CSP 26-028KB (BP012) – ADDENDUM No.02
Field House and Athletics Renovations

ADDENDUM NO. 2

FOR: BP012 FIELD HOUSE & ATHLETIC RENOVATIONS AT 10 HS'S
FOR
FORT BEND ISD
16431 Lexington Blvd
Sugar Land, TX 77479

ADDENDUM DATE: January 20, 2026

C 3.21-K
CIVIL SPORTS
UTILITY PLAN

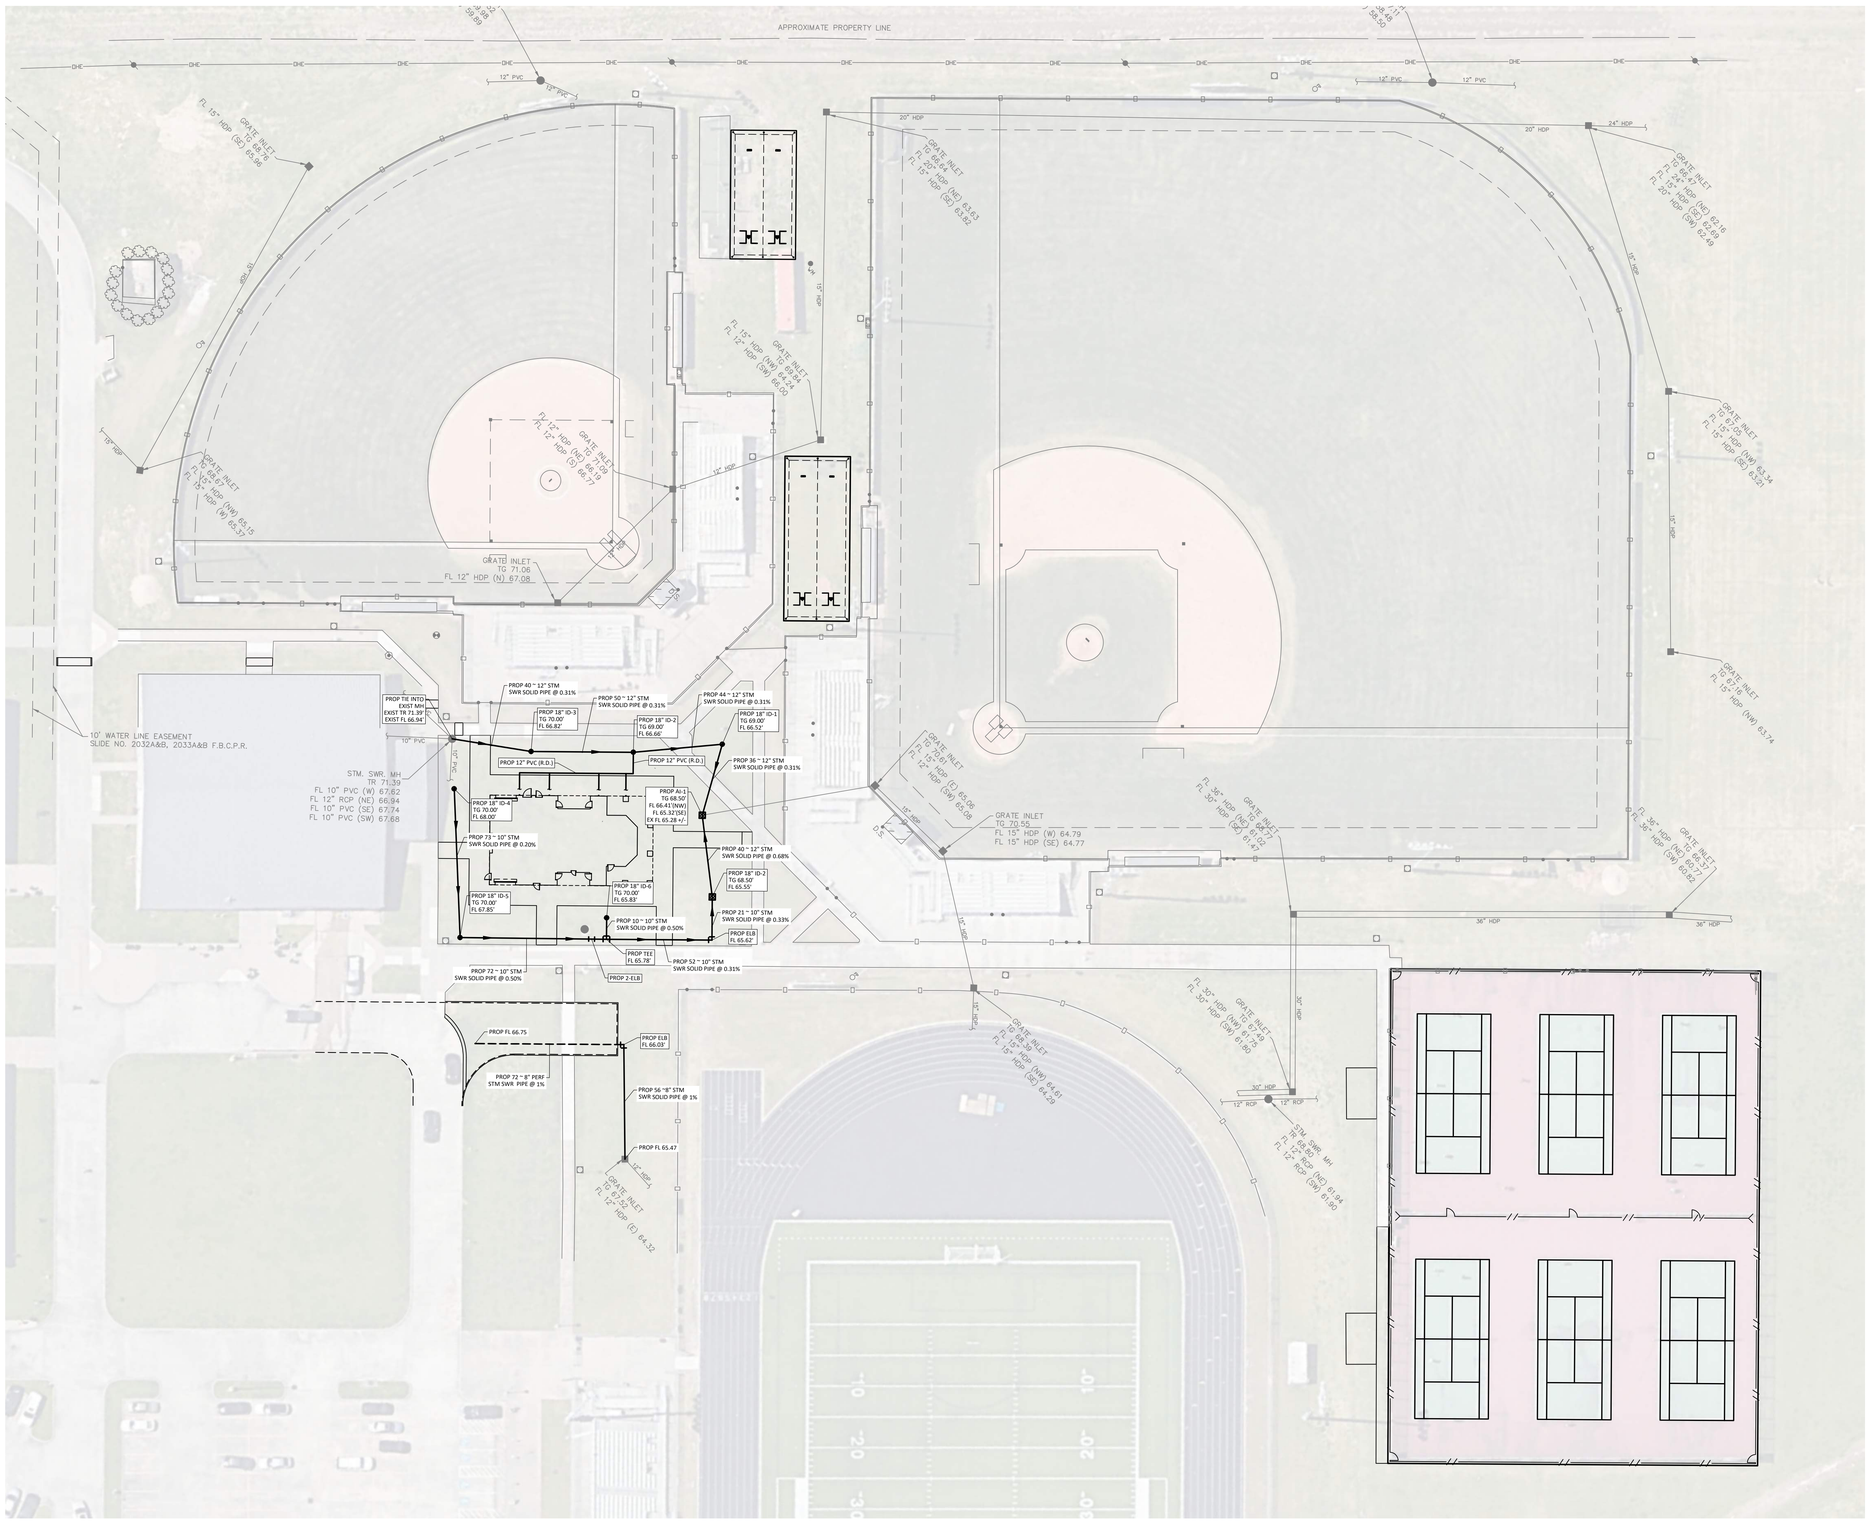
#	Date	Description
ADD-2	01/20/2026	UTILITY LOCATION

C 2.21-M
CIVIL SPORTS DETENTION POND EXPANSION & CROSS SECTIONS

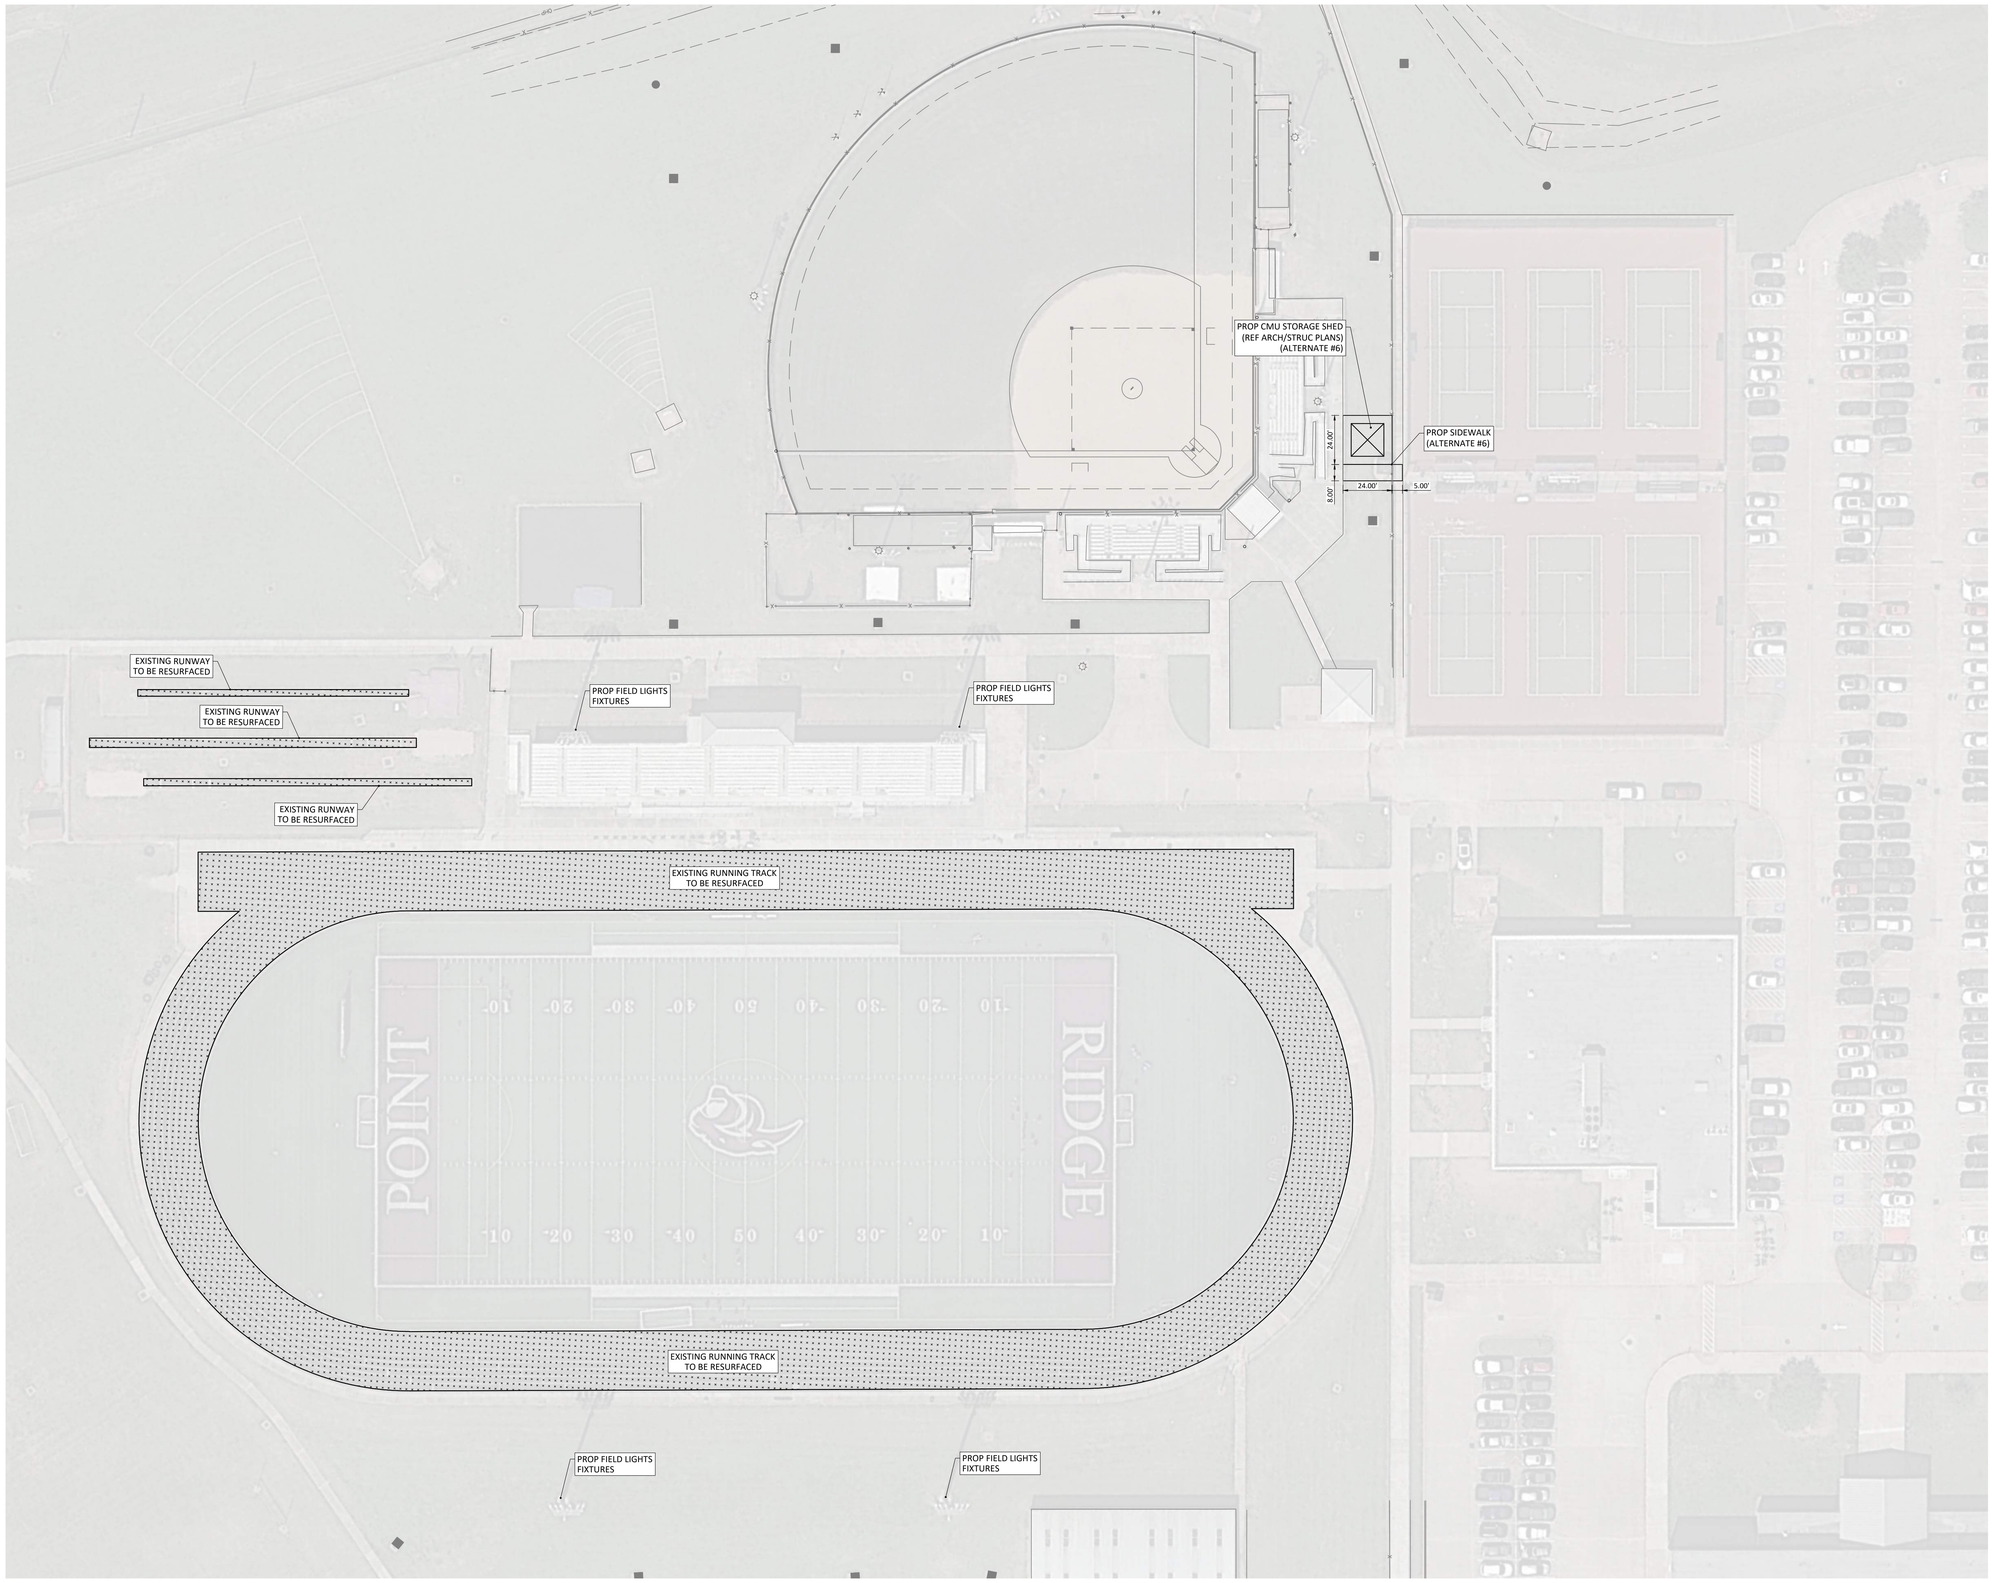
D2-17	C 2.21-M		DETENTION POND EXPANSION - added sheet
D2-18	C 1.01-W		SITE PLAN - Track note added.
D2-19	A0.01-A		Partition type 6MD updated.
D2-20	A2.01-A		Added paper towel dispenser and relocation of hand dryers. Partition Type 6MD is updated in drawings, 6MD shall go to deck.
D2-21	A8.00-A		Motorized overhead coiling door detail updated.
D2-22	G0.03-B		Code Plan Updated to show Alternate 09 Scope. Addendum #1 Date was updated to show 01/16/2026, previous date was shown 2025.
D2-23	A2.00-B		Added Locker Room scopes to project. Varsity, Jr Varisty, Sophomore and Freshman will receive New Lockers, New Flooring, New Drinking Fountain, New Paint. Revised Details 8/A2.00-B.
D2-24	A9.00-B		Updated Finishes for Locker rooms and Training Room , Locker Room scope is Alternate No.09.
D2-25	A10.00-B		Updated RCP to show new scope of Alternate 09. Updated the scope of weight room and training room to receive new ceiling tiles and lights

A2.02-E
SOFTBALL PRESSBOX AND HITTING CAGES

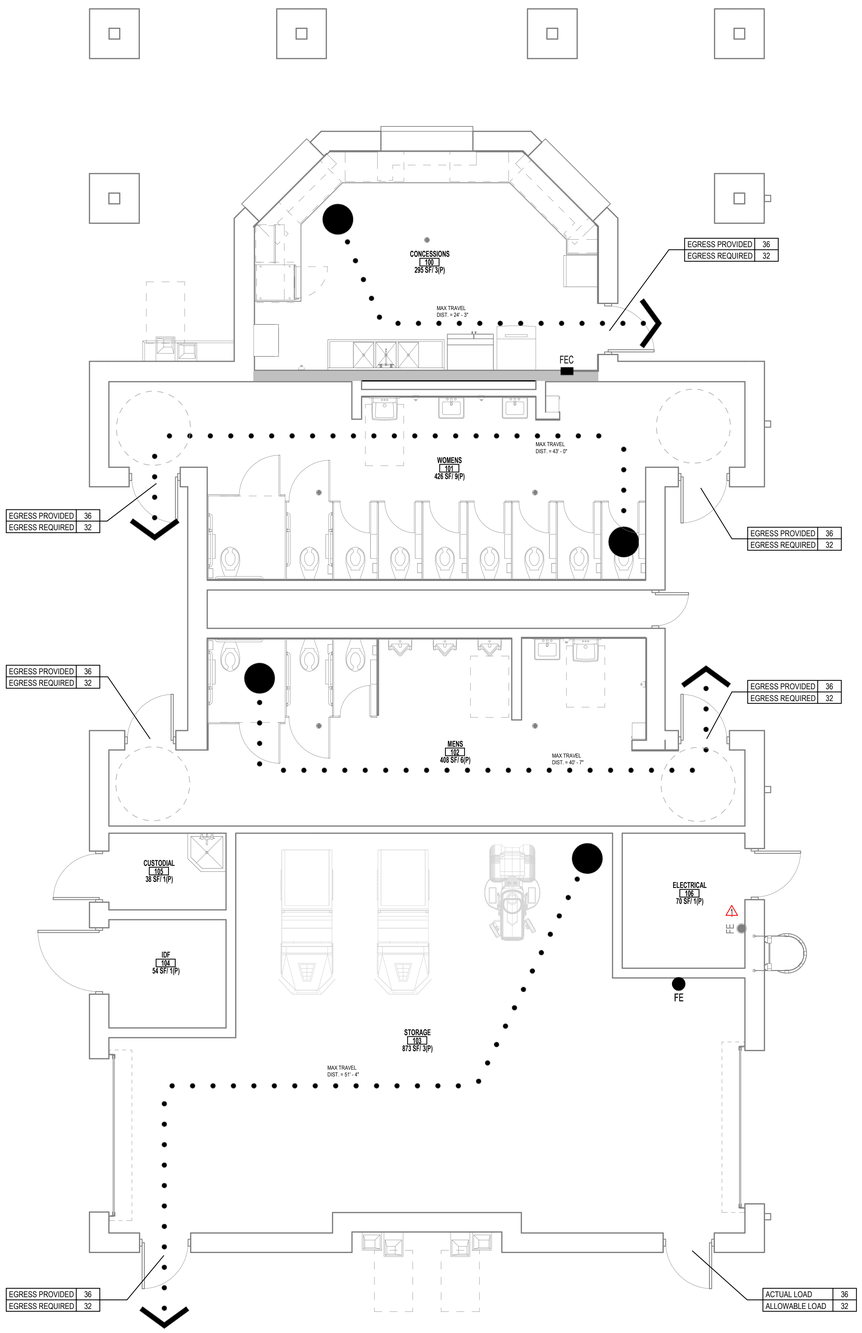
D2-26	A2.00-D		Added of paper towel dispenser. Revision to wall clearances and types. -Updated the Toilet compartment Layout of M106.
D2-27	A2.00-E		Addition of paper towel dispenser and wing wall. Revision to dimensions and relocation of accessories.
D2-28	A2.02-E		Added hitting cage dimensions, coordinate relocating existing electrical , audio and irrigation.
D2-29	G0.03-H		Revision to concessions height data. Revised egress paths to 1/G0.03.
D2-30	G0.04-H		Revision to egress width data.Revised egress paths to 2/G0.04-H.
D2-31	G0.05-H		Revision to egress width data.Revised egress paths to 2/G0.05-H.
D2-32	AD2.01-H		Revised demo scope at Showers H145 to K163 to remove existing cmu plumbing wall.
D2-33	AD2.02-H		Demolision plan updated to reflect the removed scope. Existing Lockers and Benches is removed from scope of demolision.
D2-34	A0.01-H		Partition type updated to show wall going to deck.

A2.01-H
01 FLOOR PLAN GYM

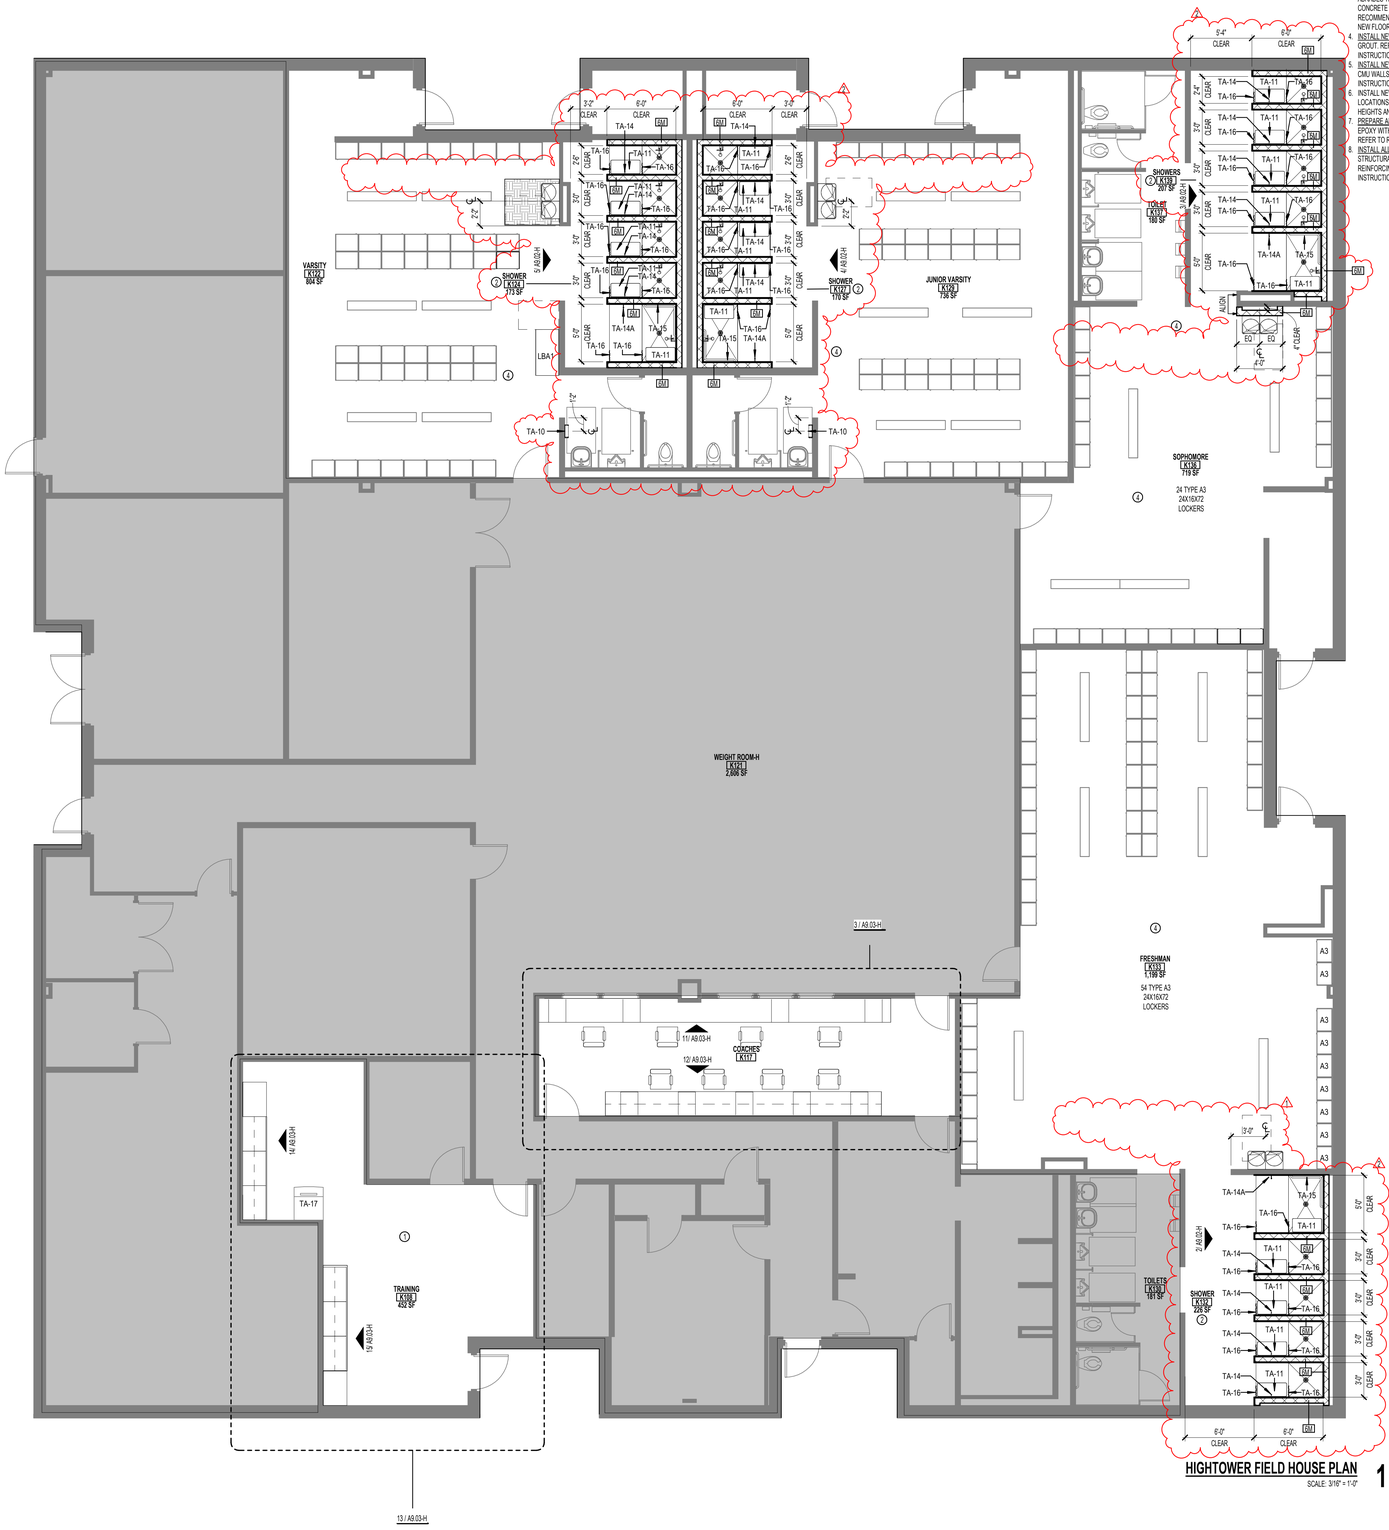
D2-35	A2.00-H		Added paper towel dispenser and wing wall. Revision to wall dimension and relocation of accessories.
D2-36	A2.01-H		Shower partition Walls Updated to 6" CMU from 4" CMU , The wall separating Boys Showers and Girls showers updated to 8" CMU to Deck.Shower Layout is updated. Added paper towel dispenser and wing wall
D2-37	A2.02-H		Addition of paper towel dispenser and wing wall. Revision to dimensions and relocation of accessories.
D2-38	A9.02-H		Revisions to plan to match revisions from 1/A2.02-H Revisions to elevation to match revisions from 1/A2.02-H
D2-39	A9.10-H		Addition of paper towel dispenser and wing wall
D2-40	G0.03-K		Revised egress path for detail 1/G0.03-K on concessions building code sheet.
D2-41	A2.00-K		Addition of paper towel dispenser and wing wall. Revision to dimensions and relocation of accessories.
D2-42	A2.01-K		Addition of paper towel dispenser and wing wall. Revision to dimensions and relocation of accessories.

A2.00-K
01 FLOOR PLAN - FIELD HOUSE

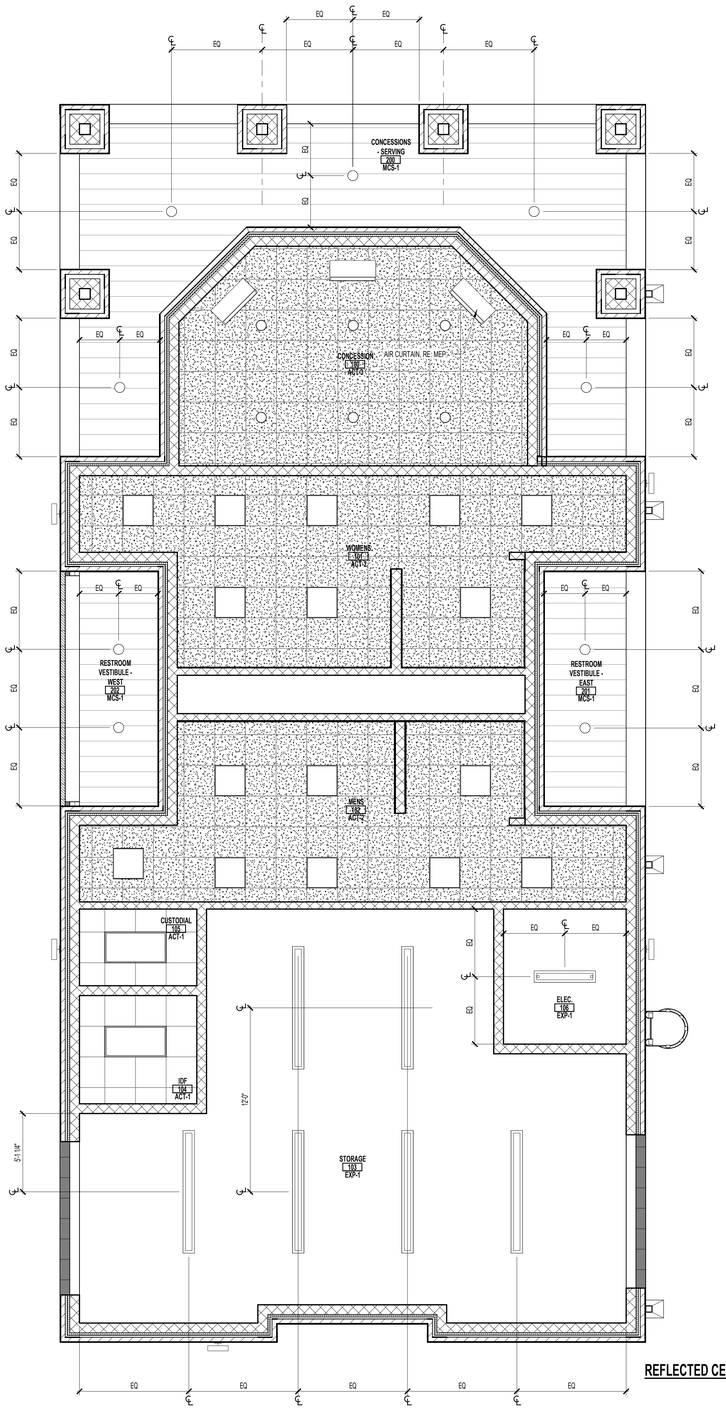
D2-43	A2.02-K		Concrete pavement around the pressbox updated
D2-44	A3.00-K		Addition of paper towel dispenser and wing wall, and relocation of hand dryers. Toilet stall door swing revision. Added soap dispenser.
D2-45	A9.01-K		Revisions to plan to match revisions from 1/A2.01-K.
D2-46	G0.03-M		Revised egress path for detail 1/G0.03-M on concessions building code sheet.
D2-47	AD.03-M		Revised demo scope at Showers H145 to K163 to remove existing cmu plumbing wall.
